Re: Notice of Termination Approval Letter for a Portion of the Site
Pennsylvania Pipeline Project (Mariner East II)
DEP Permit No. ESG0500015001
Jackson, Cambria, Munster, Cresson and Washington Townships, Cambria County
Burrell, East Wheatfield, and West Wheatfield Townships, Indiana County
Salem, Loyalhanna, and Derry Townships, Westmoreland County

EARTH DISTURBANCE INSPECTION REPORT

Project Name PA Pipeline Project/Mariner East II Inspection Date 12/7/2021 Inspection Time 8:30 AM
Weather Conditions mid 20's, cloudy Total Project Area 244 acres
Location See attached map Total Disturbed Area 244 acres
Municipality Jackson, Cambria, Munster, Cresson County Cambria
Receiving Water(s) See plans Designated/Existing Use See plans

Existing water bar - spread 2.49

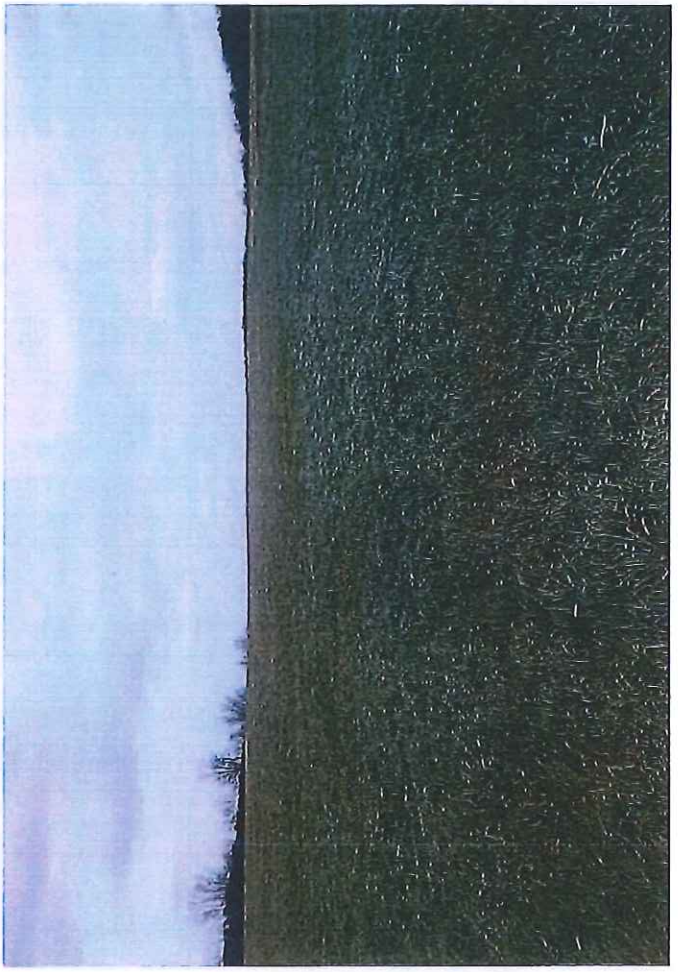
Site Description & Observations Inspection covered multiple spreads through 4 municipalities (see attached sheets ES-0.25 and ES-0.26) Locations highlighted in yellow. In areas identified with the black LOD (areas for partial termination) all vegetation observed was 70% vegetative cover or greater. The vegetation observed had thick healthy coverage. All temporary E&S BMPs were removed in these areas aside from 1 temporary waterbar on spread 2.49. It was reported by the site representative that this waterbar is necessary to prevent erosion of a steep slope upgrade of UNT to N. Branch of Little Conemaugh. Spread 2.31 has two temporary waterbars removed and a permanent water bar location that is not correct per plan. (see attached drawing) These areas are to be approved as redline changes or this area will need to be revised to show that it will be renewed for permit coverage and is not able to be terminated at this time. (Labelled using blue LOD)

Spread 2.06 disturbance

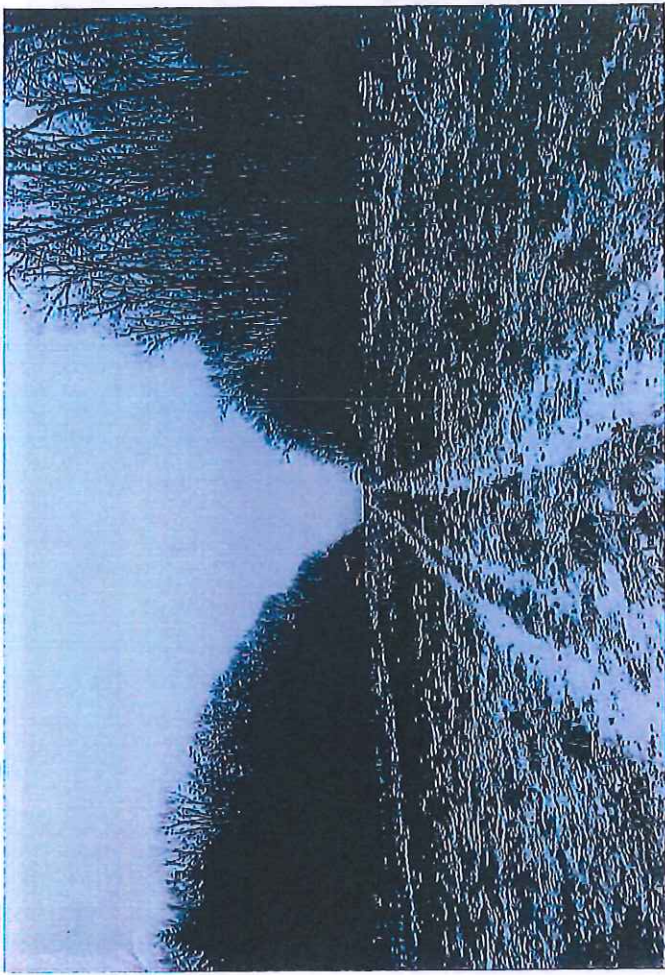
Compliance Assistance Measures The small area of disturbance within the LOD on spread 2.06 does not meet the criteria of permanent stabilization. It is recommended that plan drawings should be adjusted using a blue LOD in this area. This small area should not be terminated at this time due to the lack of vegetative cover.
